LIGO-E1100050-v4

Responses to ACB FDR Questions

This document presents the answers to the AOS SLC Arm Cavity Baffle design review committee. The questions were posed in M1100009-v1.

Figure 1: Locations of Photodetectors in 2-Hole ACB

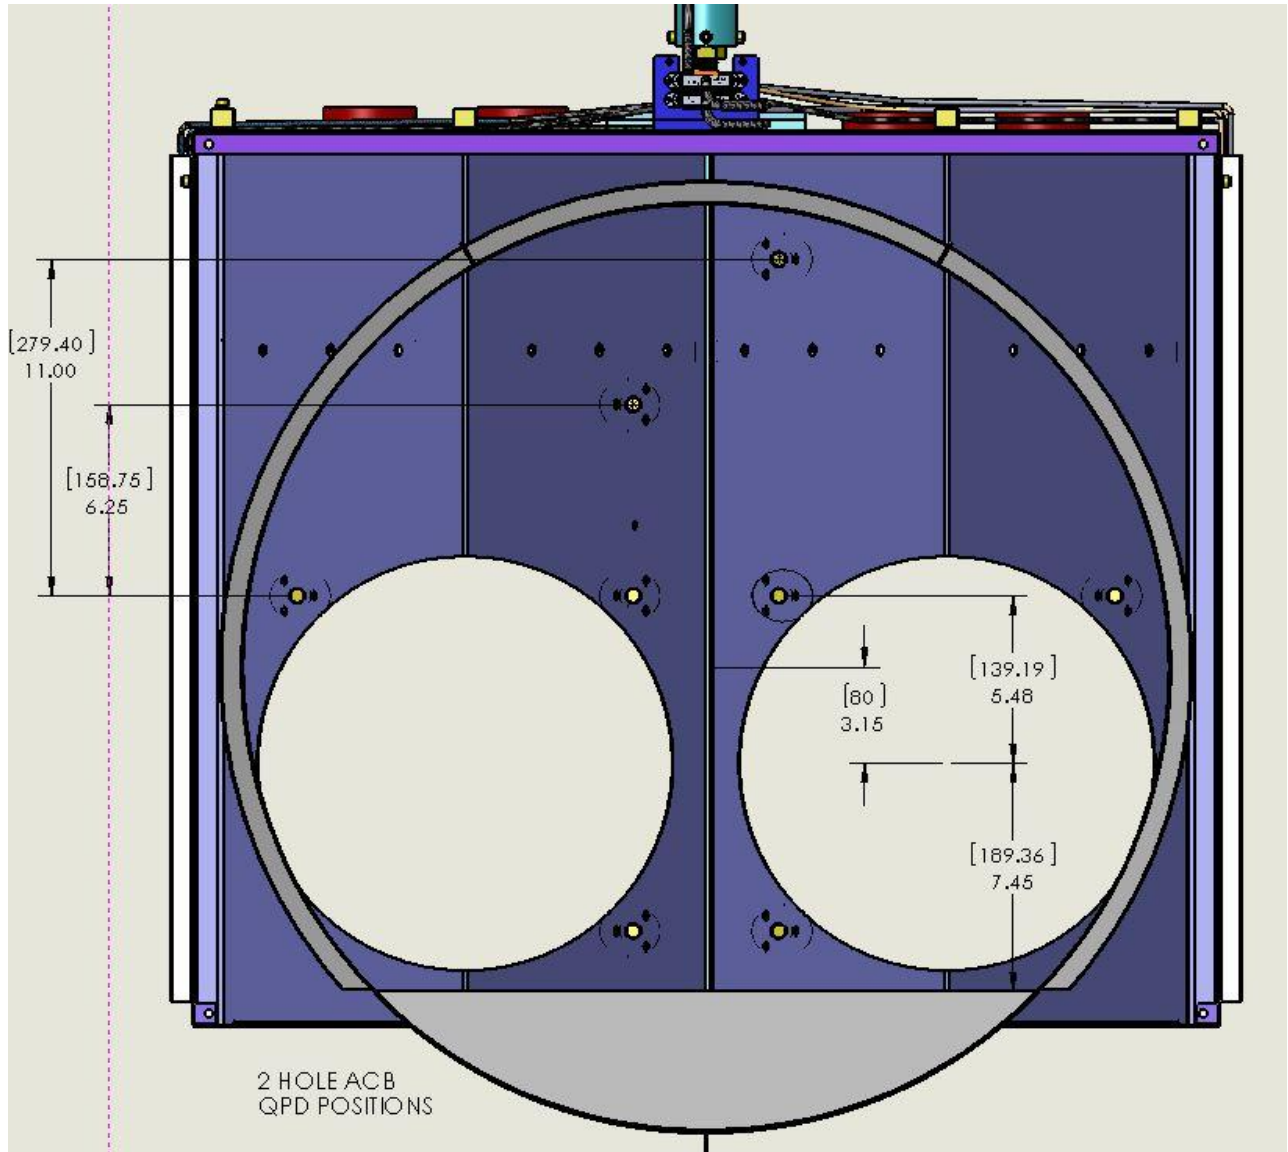
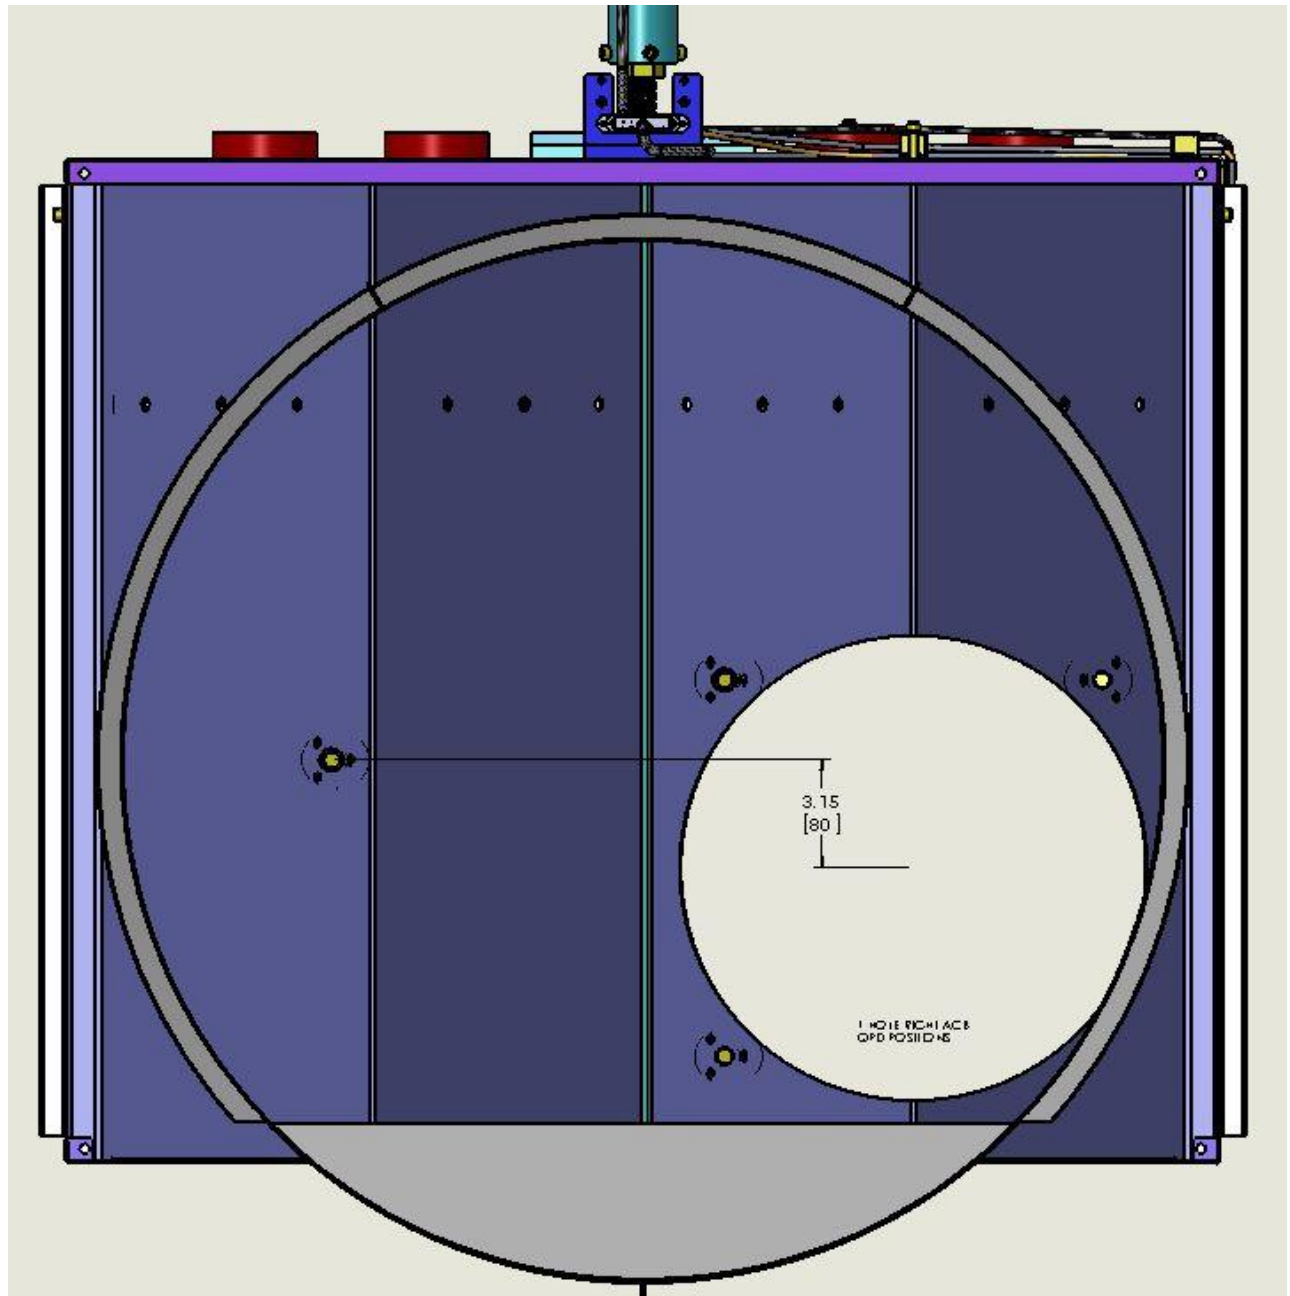
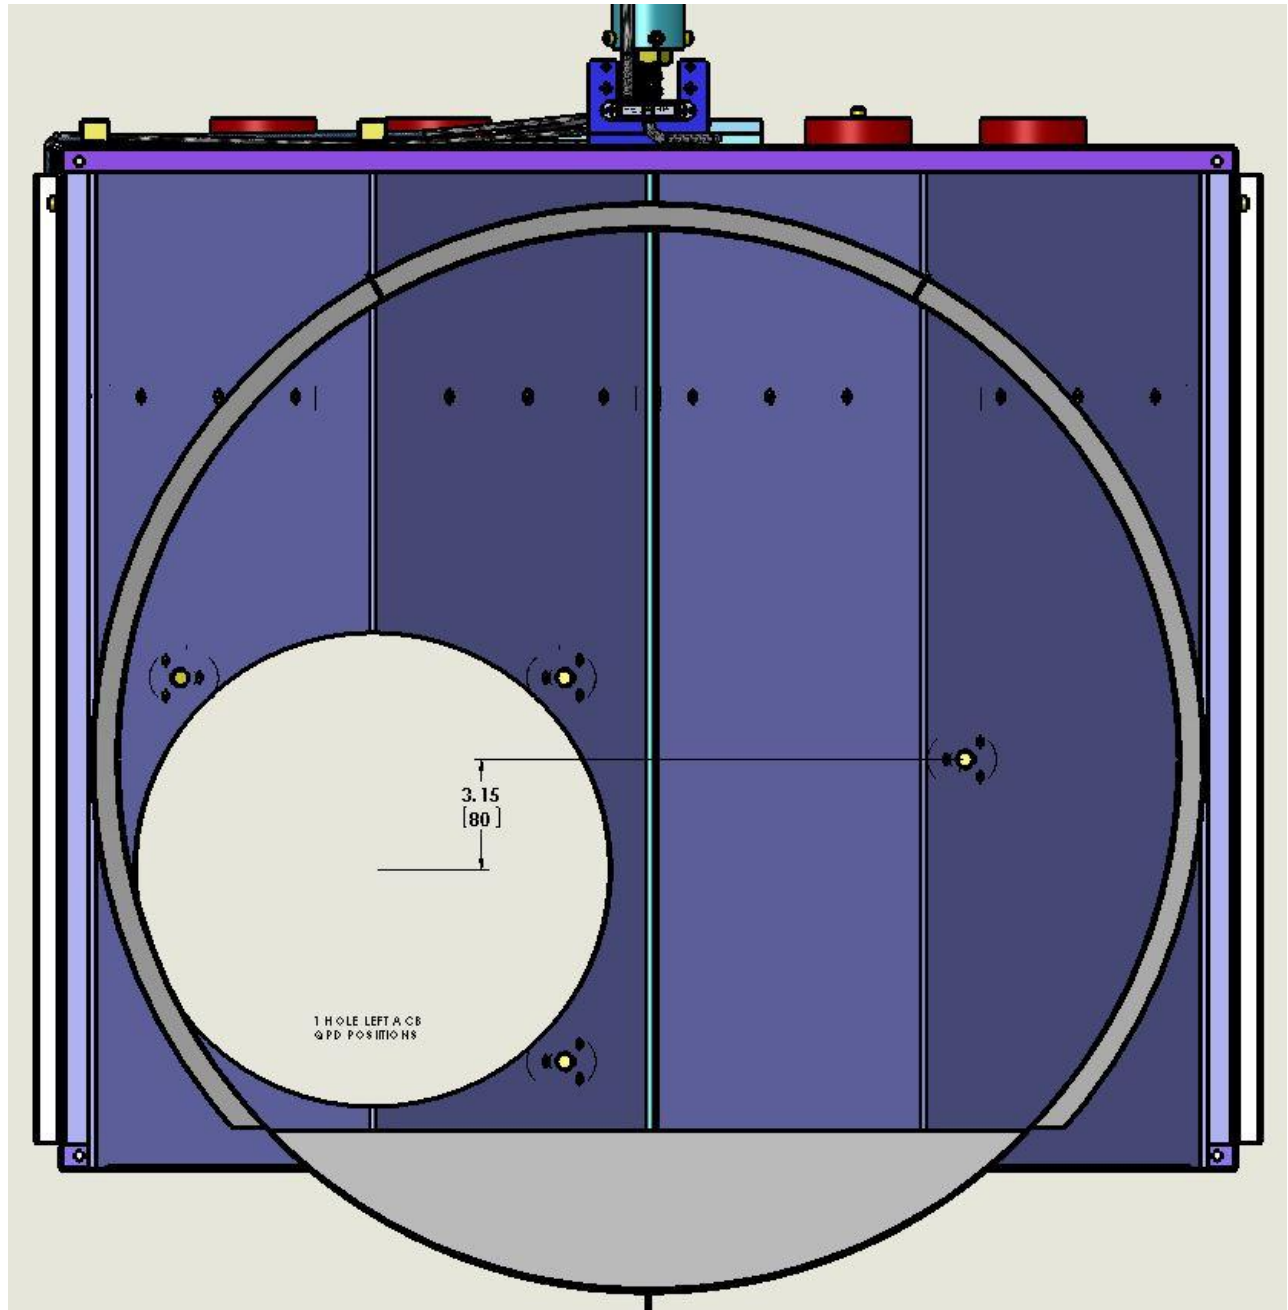
Position of photo-detectors

Figure 4: TM Wide Angle Scatter, re-scattered by ACB surfaces

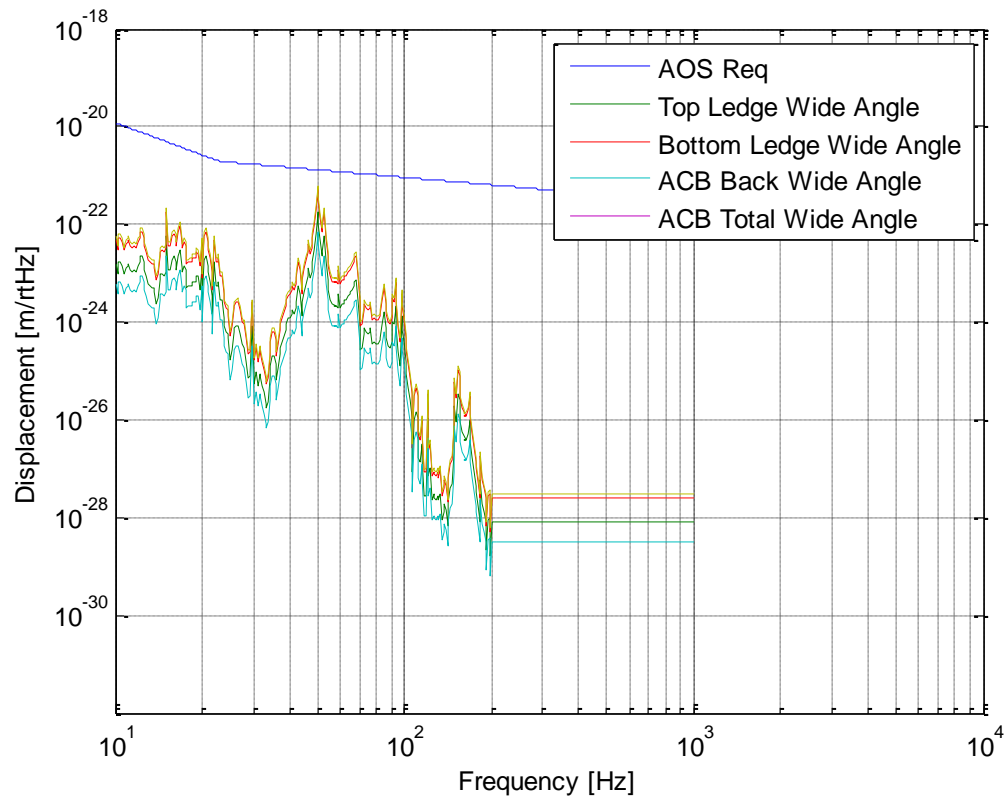
The new photodiode hardware on the back of the baffle, which has shiny components such as silver plated screws, should be checked to be sure that diffuse large angle scattering is not a problem, or it should be covered with a baffle. To prevent specular reflections we should watch for surfaces on the back side of the baffle that are nearly normal to a radius from the center of the optic face (such as the PEEK backs of the photodiodes and the edges of the shelves).

A ZEMAX simulation of diffuse scattering from the surface of the ITM showed that no specularly reflected rays will return to the COC mirror. The diffuse scattering from the Peek and from the cabling does not cause excessive displacement noise, as shown in Figure 4.

Figure 5: TM Wide Angle Scatter, re-scattered from Chamber Walls and Manifold

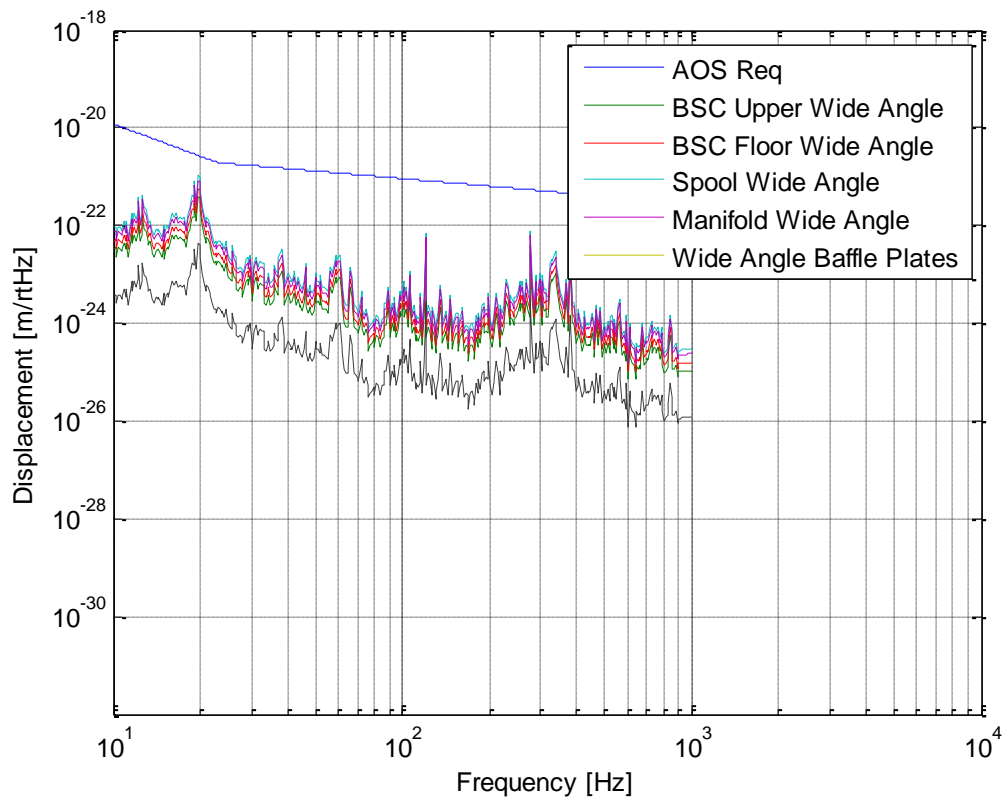
a) Is this acceptable, do we need further baffles in the manifold tube?

No, see Figure 4 and Figure 5

Figure 6: ZEMAX Lambertian Scatter Ray Trace from H1 ITMX HR, Top View

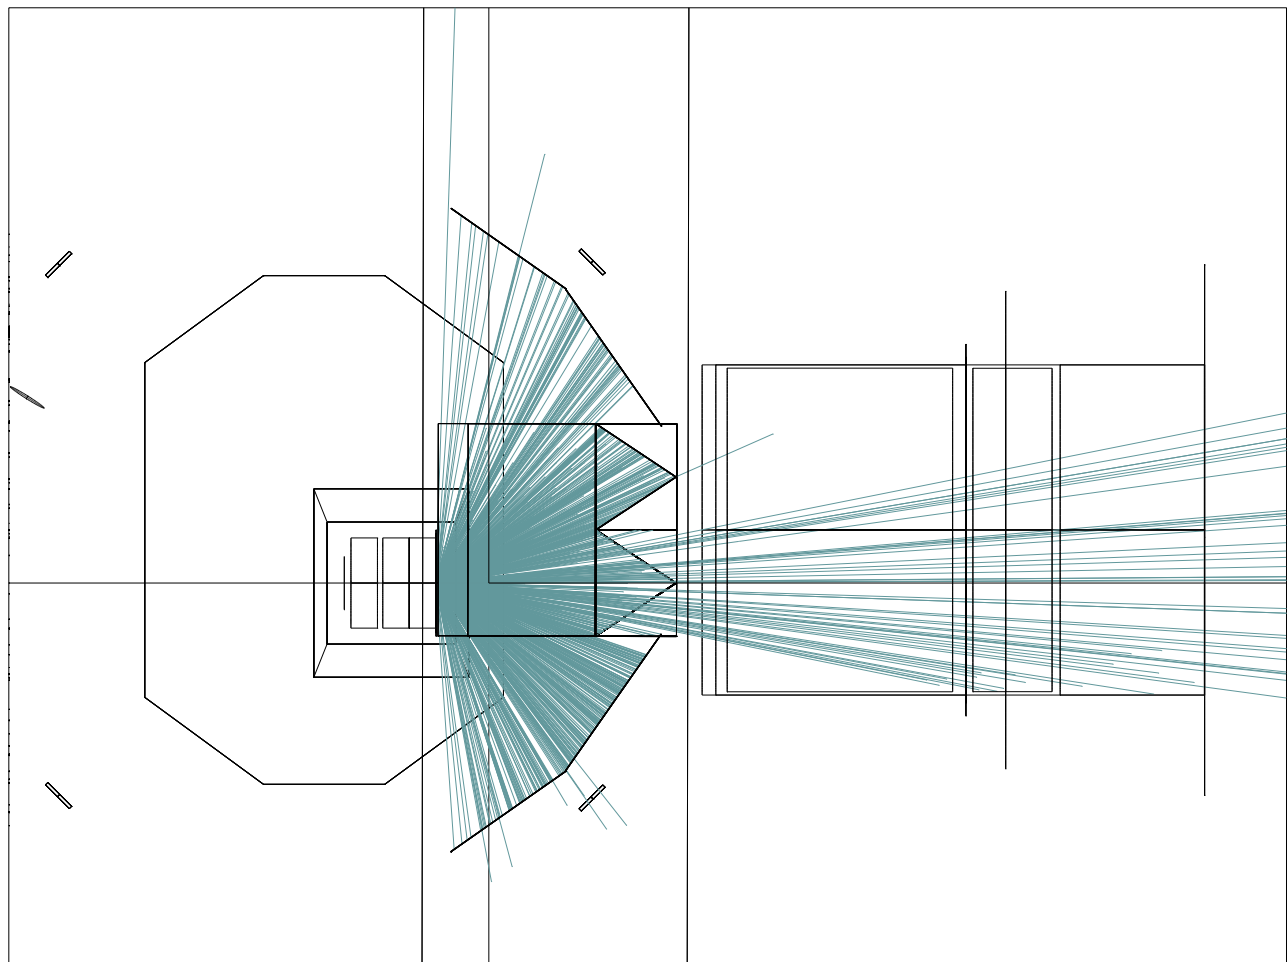
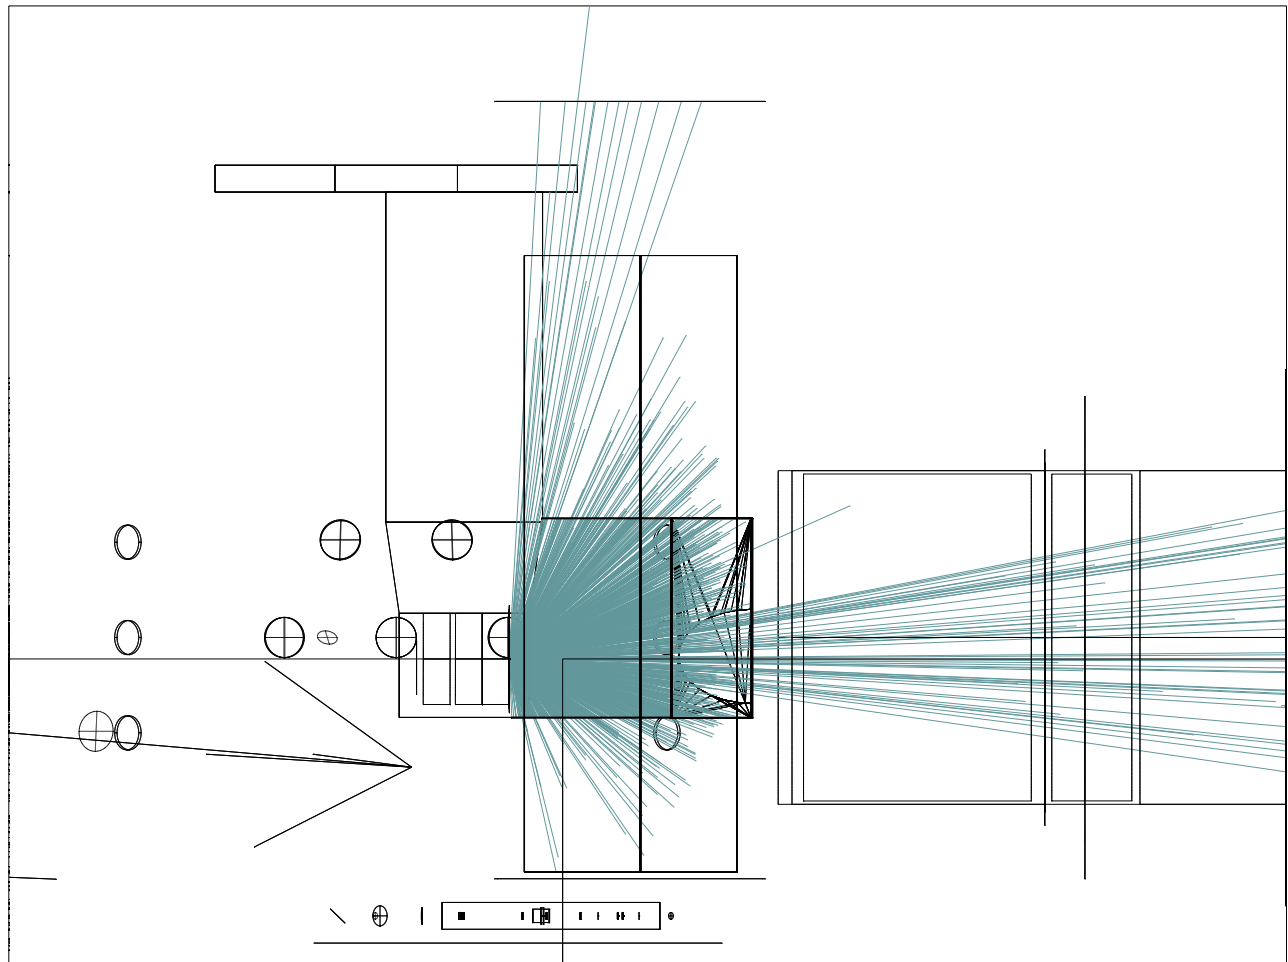
Are there any clear paths between the center of the optic face and the table that are not blocked by the baffle (especially since the top shelf is short)? I worry about this for large angle scattering.

The Lambertian scattering from the H1 ITMX HR surface was analyzed with ZEMAX ray tracing. The table below summarizes the fractional power hitting each of the surfaces listed. A pictorial view of the wide angle scattered light is shown in . The light that is not caught by the ACB baffle and the upper and lower ledges, 1) hits the upper and lower portions of the BSC, 2) is caught by the wide angle baffle plates, 3) passes through the BSC flange and hits the adjacent spool piece, and 4) the remainder of the light passes into the following BSC chamber or into the manifold (for L1 and H2). The calculated displacement noise cause by re-scattering from each of the listed surfaces is shown in Figure 4 and Figure 5

Figure 9: SUS Wide Angle Scatter

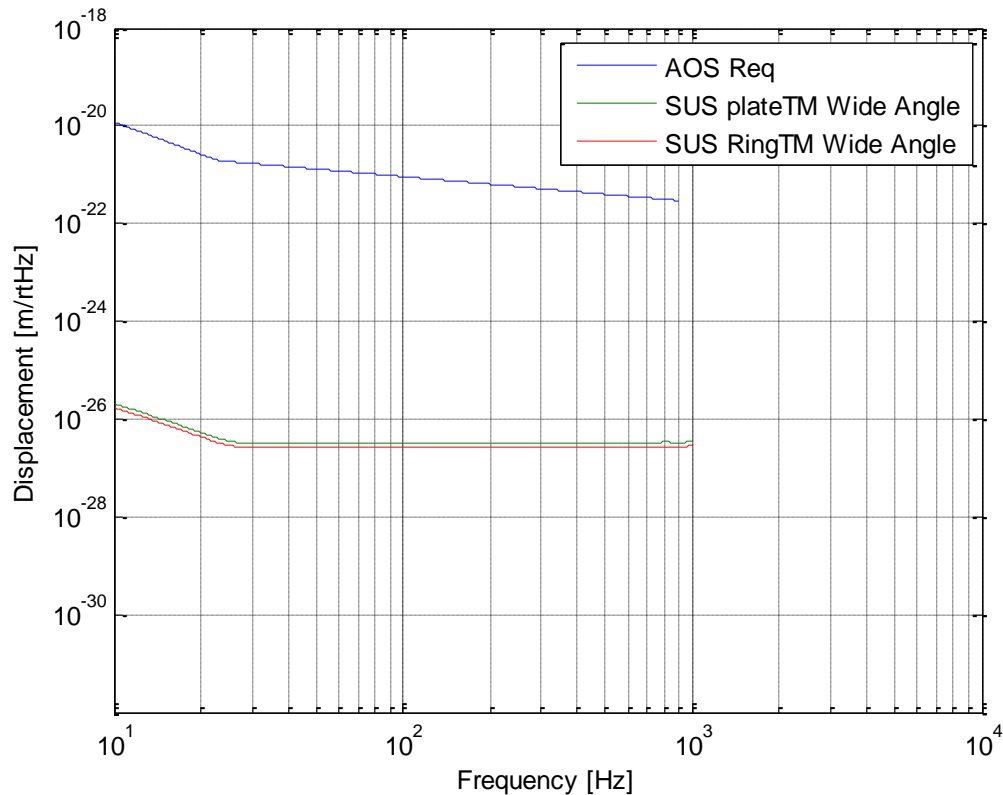
13) NEW QUESTION RE: WIDE ANGLE SCATTERING FROM THE SUS STRUCTURE

The quad SUS lower structure has an octagonal structural ring that surrounds the HR surface of the TM, which will catch some of the wide angle light scattered. A structural plate above the ring with an extended ledge will block the wide angle scattered light from hitting the upper stage of the SUS. The wide angle scattering displacement noise from the octagonal ring and ledge was calculated and are shown in Figure 9.
